Mr. Robert Hermann
U. S. Nuclear Regulatory Commission
Washington, DC 20555-0001

I have reviewed the memorandum from Jack Rosenthal to Jack Strosnider dated October 20, which suggests that an error was made in the crack growth calculations which were carried out for the cracked head penetration at D. C. Cook Unit 2, and reported in WCAP 14118 Rev. 1, dated October 1994. The conclusions of this memorandum are incorrect, and the purpose of this note is to set the record straight.

DEVELOPMENT OF A CRACK GROWTH RATE MODEL FOR ALLOY 600 HEAD PENETRATIONS IN PWR ENVIRONMENT

Figure 1. Scott's Alloy 600 Crack Growth Model [1]
Note the typographical error in the upper curve caption.

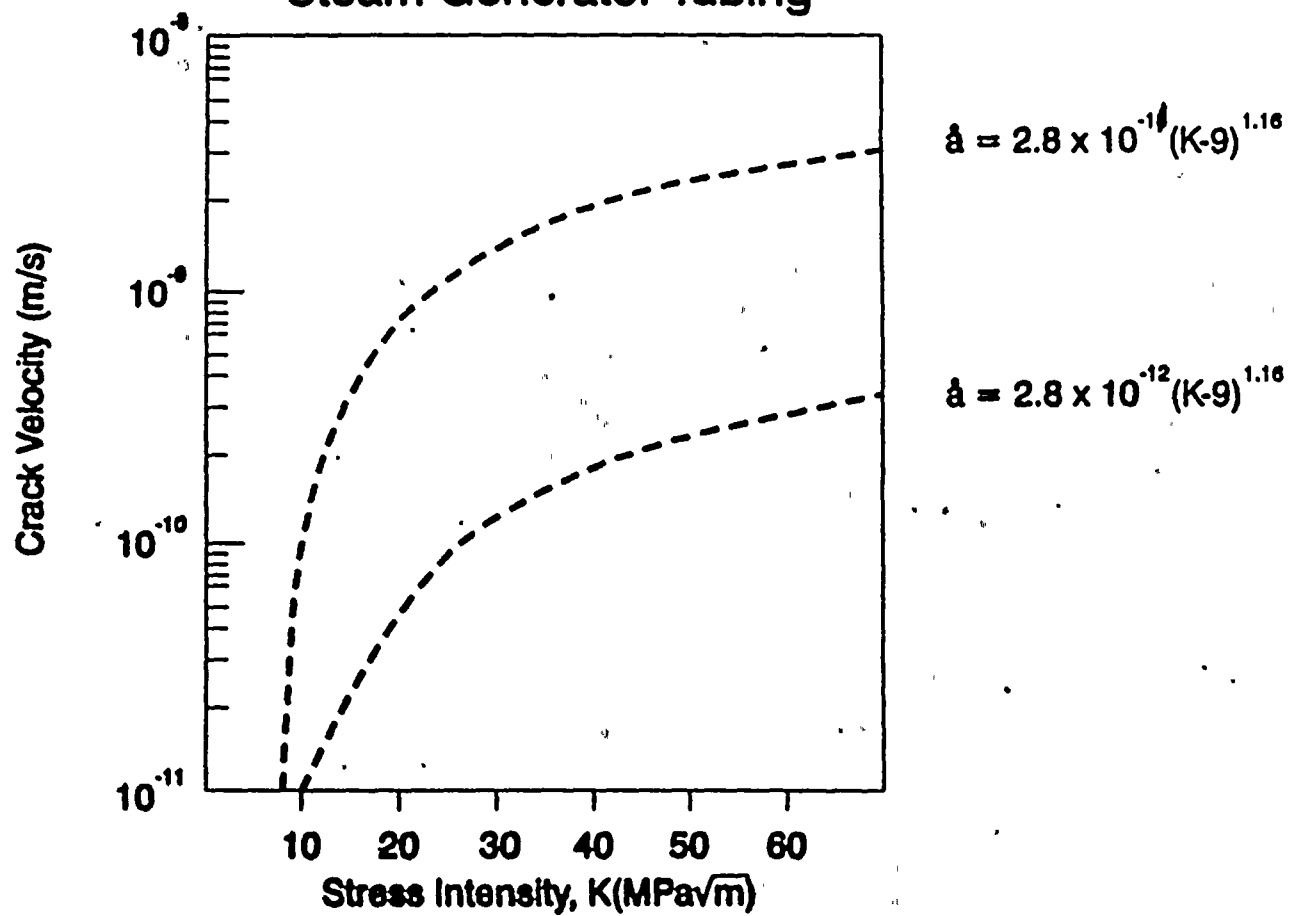
where K is in $\text{MPa}\sqrt{\text{m}}$. This curve is plotted as the top curve of Figure 1, which unfortunately contains a typographical error in the label.

The next step described by Scott in his paper was to correct these results for the effects of cold work. Based on work by Cassagne and Gelpi [3], he concluded that dividing the above equation by a factor of 10 would be appropriate to account for the effects of cold work. This step was inadvertently omitted from Scott's paper, even though it is discussed. The crack growth law for 330°C then becomes:

$$\frac{da}{dt} = 2.8 \times 10^{-12} (K-9)^{1.16} \text{ m/sec}$$

Figure 2. Woodman's Independently Developed Alloy 600 Crack Growth Model [4]

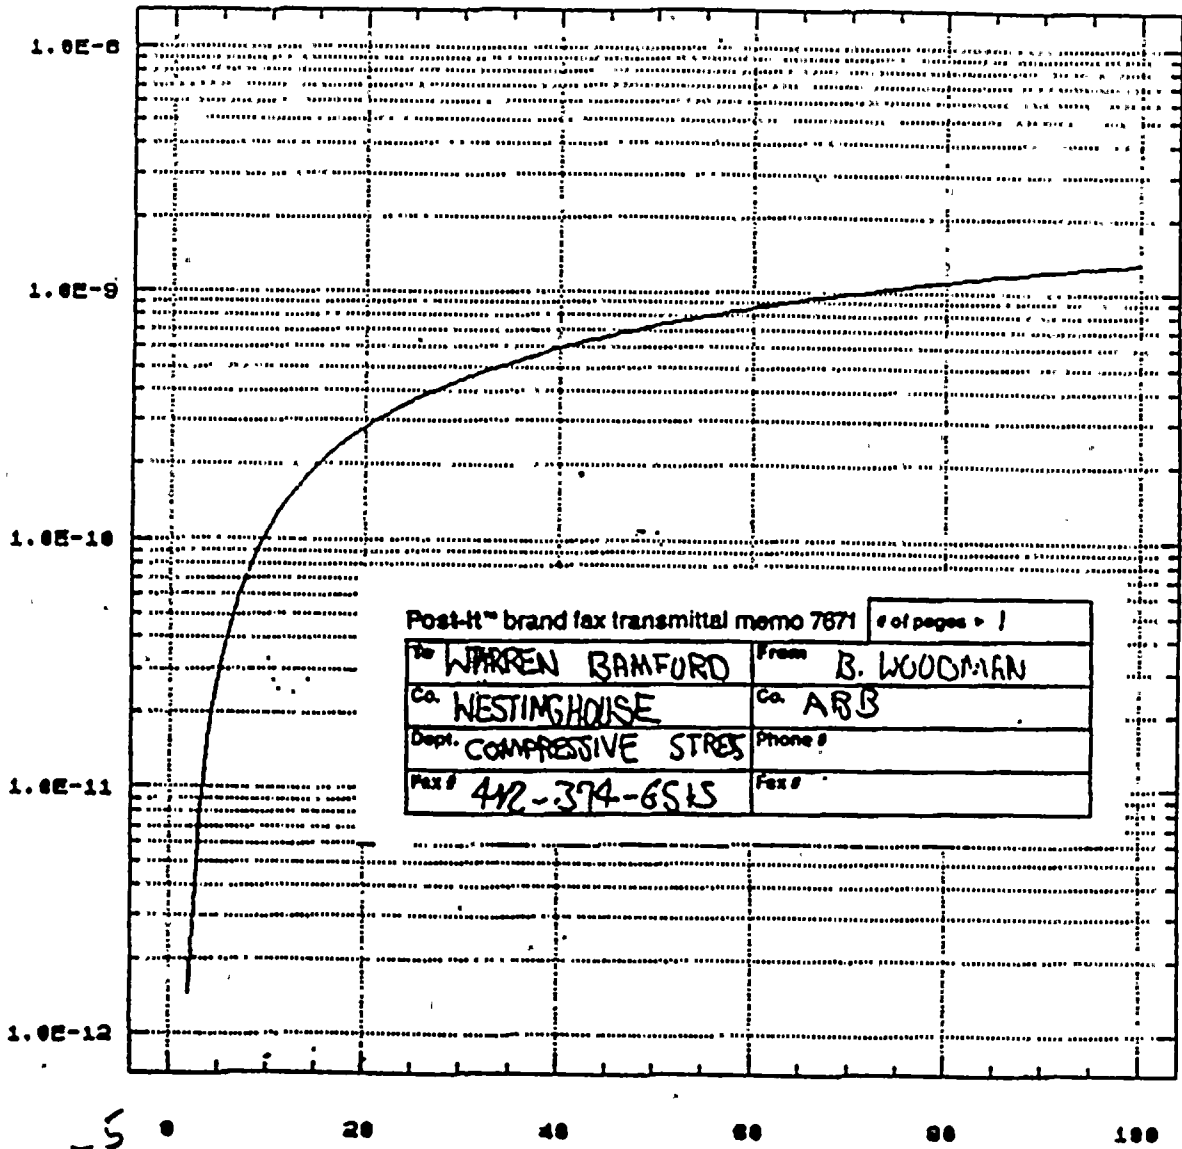
This equation is nearly identical with Peter Scott's original model uncorrected for cold work, as shown in Figure 2. This work provided an independent verification of Scott's work.
